Environmental Review Team Report
Corson & Kranc Subdivision
Brooklyn, Connecticut

Environmental Review Team
Report

Corson & Kranc Subdivision
Brooklyn, Connecticut

March 1983

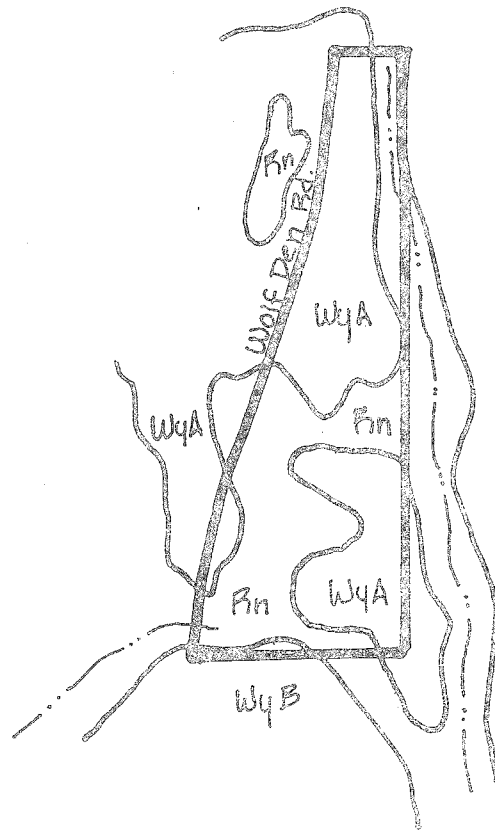
Lots #'s 1, 2, and 5 seem to have the least problems and homes could be constructed as indicated on the plans. Removal of stones on lots #'s 1 and 2 would represent the biggest limitation and cost for development on these sites.

Lots #'s 4 and 6 are the greatest areas of concern and perhaps plans should be revised to combine these with other lots to minimize potential problems. Combining lots 3 and 4 and lots 5 and 6 to result in a total of 4 lots on the entire parcel would be a possible revision. This would minimize potential problems of separating distances and location of on-site septic systems and water supplies and provide lots which would be least likely to have drainage problems. This would also minimize the potential damage to adjacent wetlands from development in such close proximity.
